MEMORANDUM

THE MARYLAND-NATIONAL CAPITAL PARK AND PLANNING COMMISSION

REVIEW TYPE: Site Plan Review concurrent with Preliminary
Plan Review
APPLYING FOR: Approval of 48 residential units on 6.32 acres,
that includes 42 townhouses and 6 MPDU (duplex) condominium units
PROJECT NAME: **Baum Property**
CASE #: 8-05012
REVIEW BASIS: Sec. 59-D-3, Zoning Ordinance: Site Plan required in the RT-8 Zone

ZONE: RT-8
LOCATION: The Intersection of Valley Park Drive and Coltrane Drive
MASTER PLAN: Damascus
APPLICANT: Elm Street Development
FILING DATE: October 10, 2004
HEARING DATE: January 20, 2005

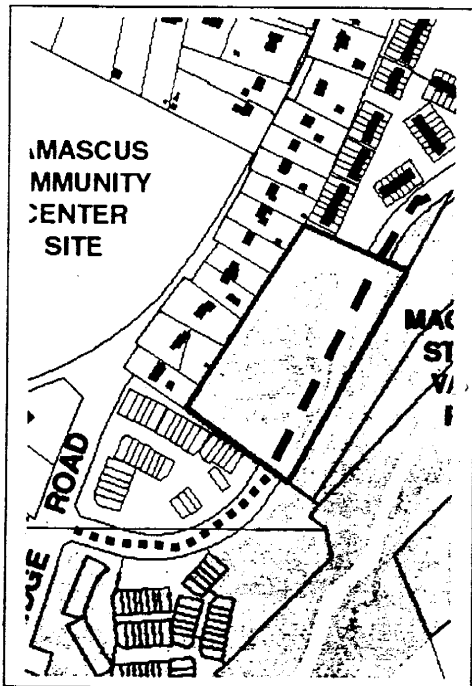
Staff considered the provision of the Class I bike path and improvements to enhance pedestrian safety of primary importance to the concurrent Preliminary and Site Plan Reviews. Collaboration between the applicant, and the staffs of Parks, Transportation Planning, Subdivision, DPS, and DPWT produced specific solutions for the provision of the off-road bike path along the Baum Property frontage and for the adjacent Elm Street Development subdivision. Per the schematic, revised design, the road section will feature a 6-foot grass planting strip adjoining the curb to accommodate full-size shade trees, and an 8-foot asphalt hiker-biker trail, with variable dimension for the area supporting the continuous retaining wall that is closest to the property line. [See graphic below.]

The applicant agrees with the recommendations of MNCPPC staff, DPS, and DPWT for the provision of the off-road bike path. As described by DPWT planners, the applicant has agreed to provide the bike path or widened sidewalk along the Valley Park Drive frontage for the subdivision adjoining the Baum Property to the south. The applicant has further agreed to provide the street trees at the typical spacing of 40-50 feet on center within the curbside planting strip in the event DPWT is unable to do so at the completion of the road construction.

The dotted line indicates bike path section provided by the applicant; the dashed line shows DPWT portion

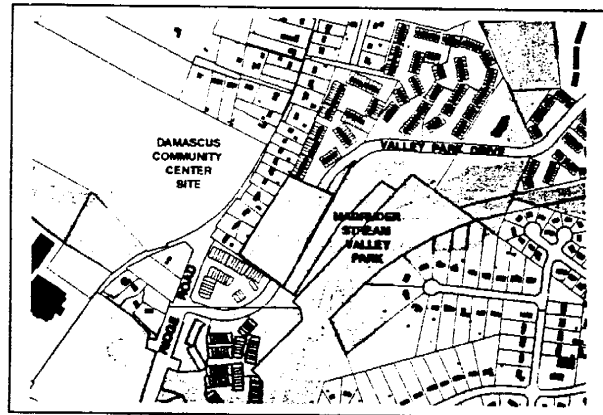
Provision of the Valley Park Drive Class I bike path fulfills a significant goal of the pending Damascus Master Plan Amendment. The applicant will provide the bike path along the Magruder Overlook subdivision frontage. Clearly, the intensive effort put forth by DPS and DPWT propelled this development application, at the eleventh hour, to achieve a major goal of the master plan process and provides a convincing example of successful and timely inter-agency coordination.
